1 Site Plan
1" = 20'-0"

La Morada Commercial Development
7501 La Morada Pl. NW
Albuquerque, NM 87120

TCL1.0

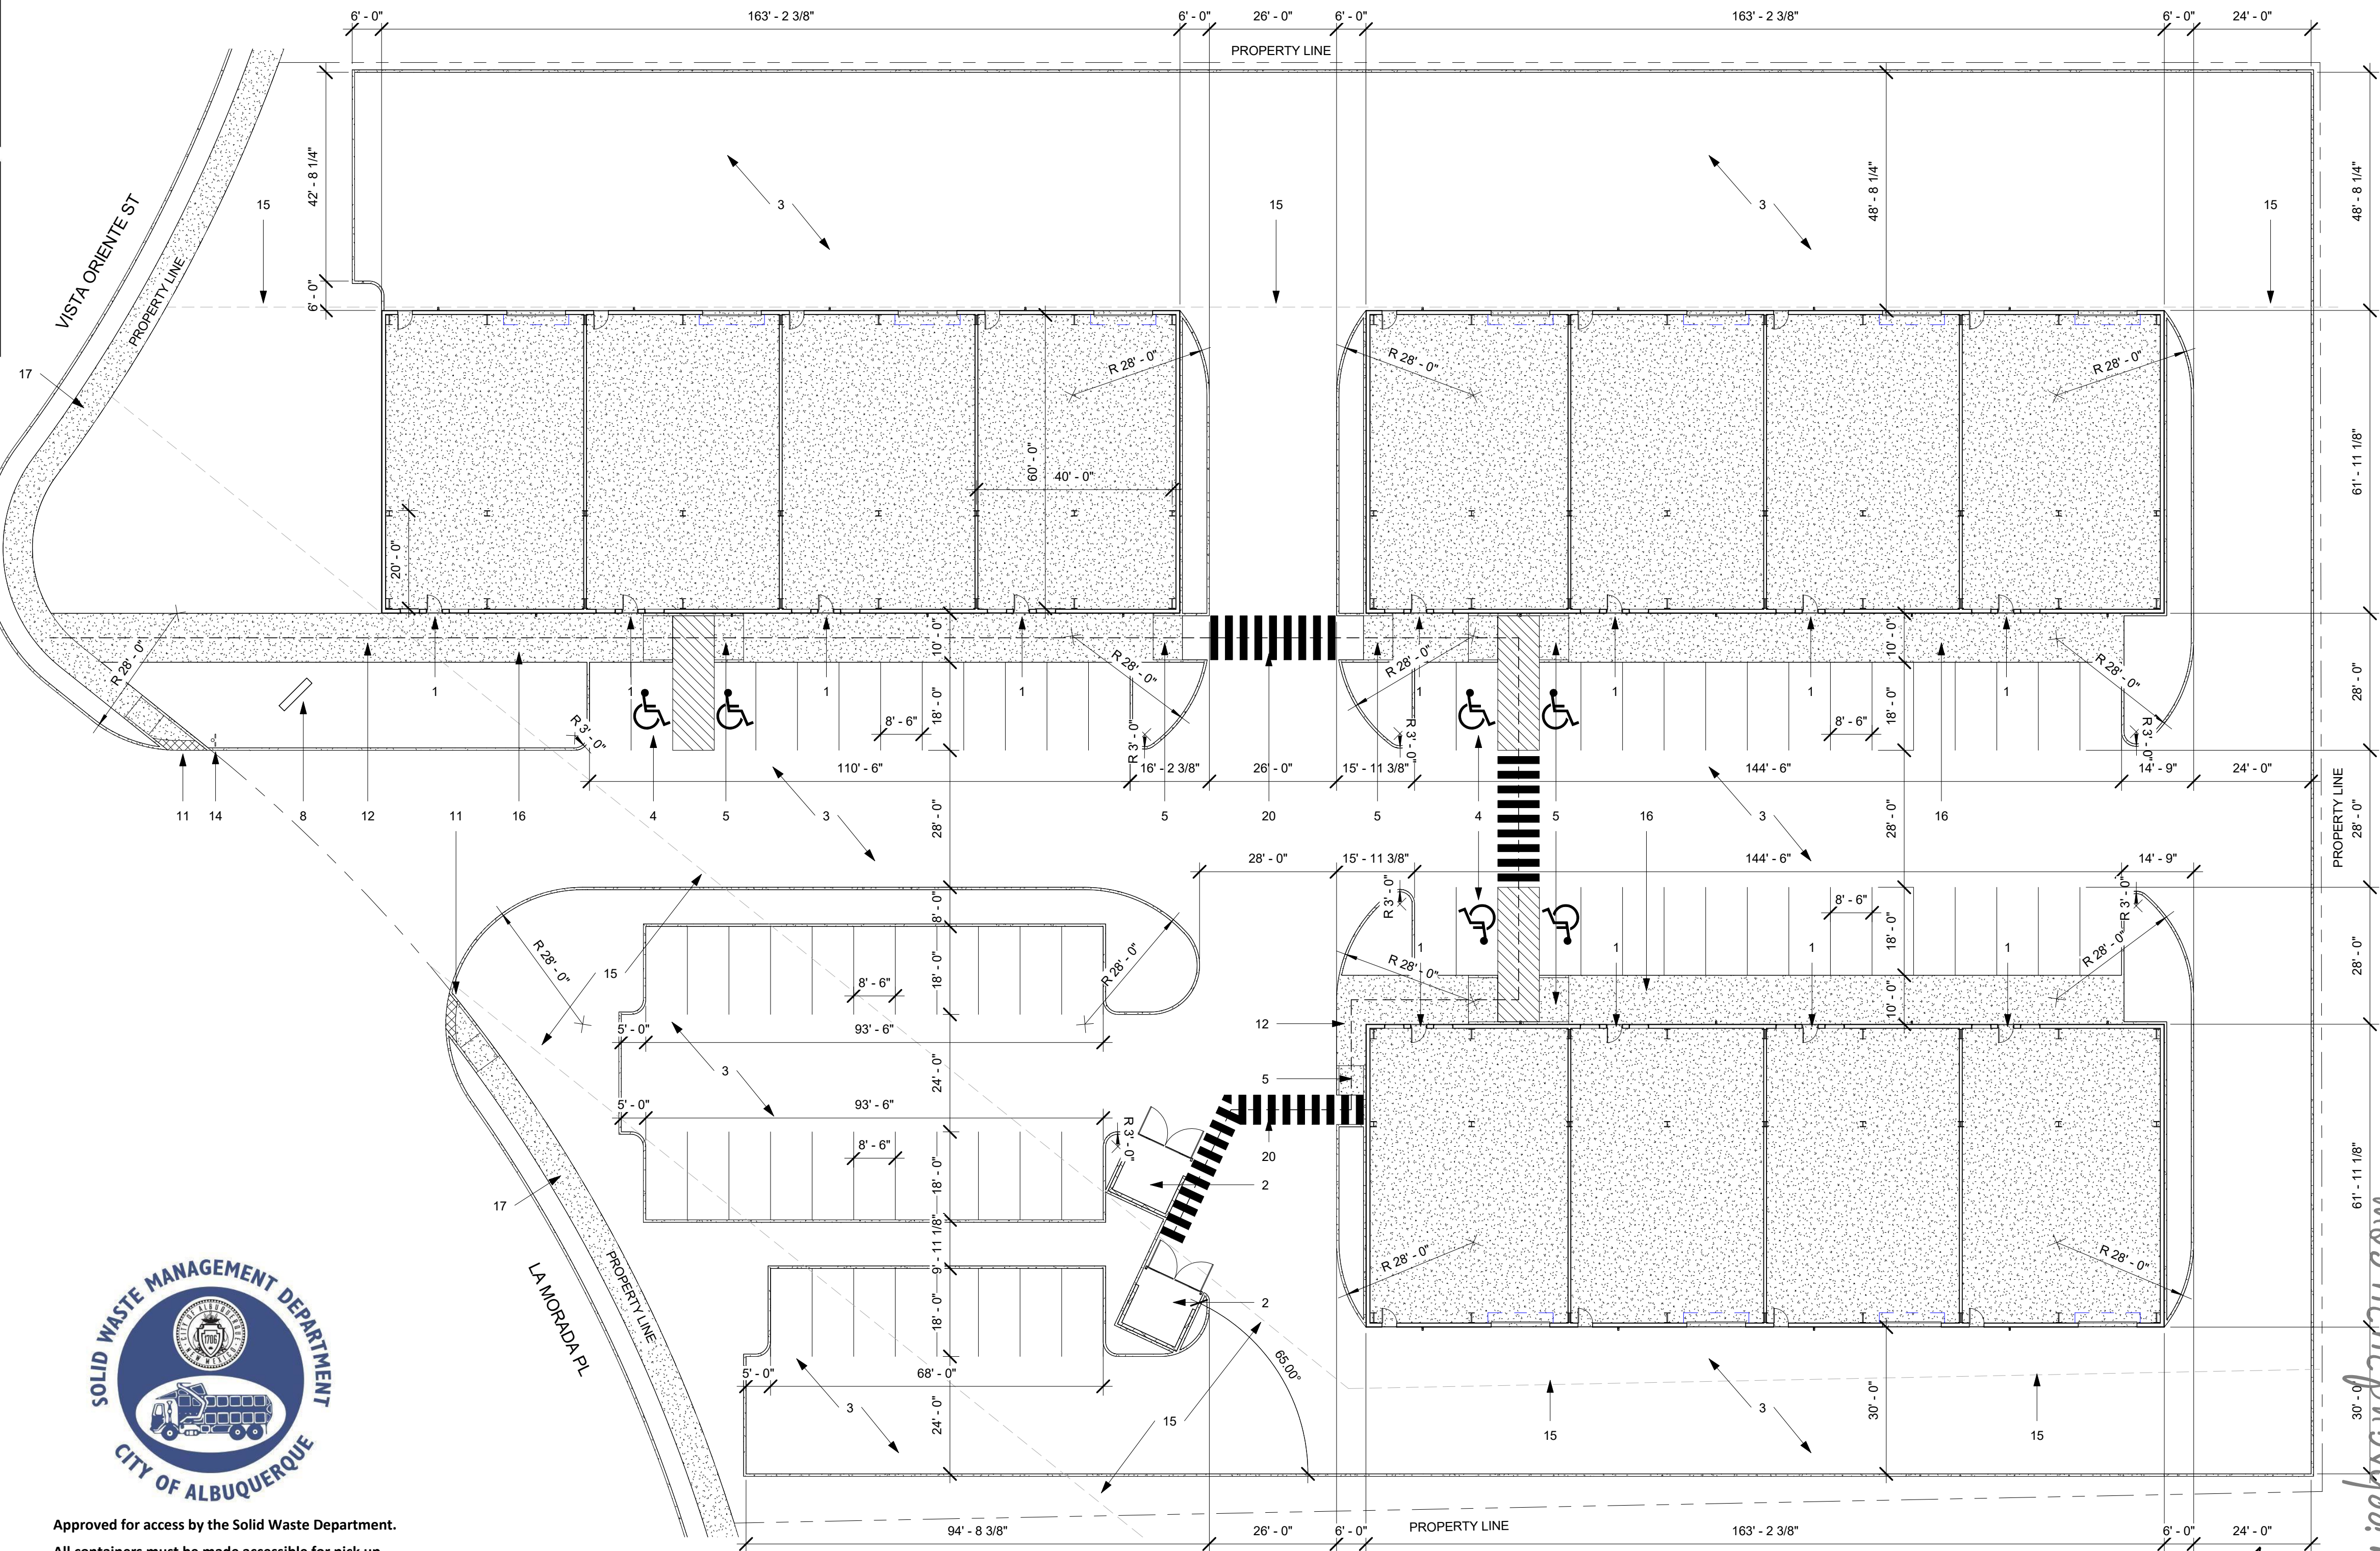
Approved for access by the Solid Waste Department.

All containers must be made accessible for pick up between the hours of 5AM and 8PM.

Recycle Declined
